TO: Mercedes-Benz Dealer Principals, General Managers,	FROM: Gregory Gunther, Department Manager, Vehicle	
Sales Managers, Service Managers, Parts Managers	Compliance and Analysis, Engineering Services	
RE: Recall Campaign Launch Notification		
Check the Voltage Converter	DATE: August 27, 2021	
MY20 247 (GLB-Class)

Recall Campaign Bulletin

Campaign No. 2021080005, August 2021

Check the Voltage Converter

Figure 1

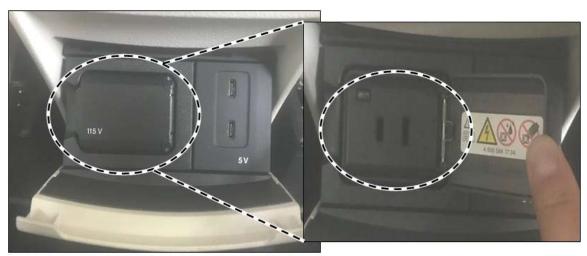
1. Use multimeter to check voltage at 115-volt socket in rear passenger compartment (Figure 1). i The voltage *must be between 110–120 volt (Figure 2)*!

- a. Voltage at 115-volt socket not OK: Carry out work procedure.b. Voltage at 115-volt socket OK: End measure.
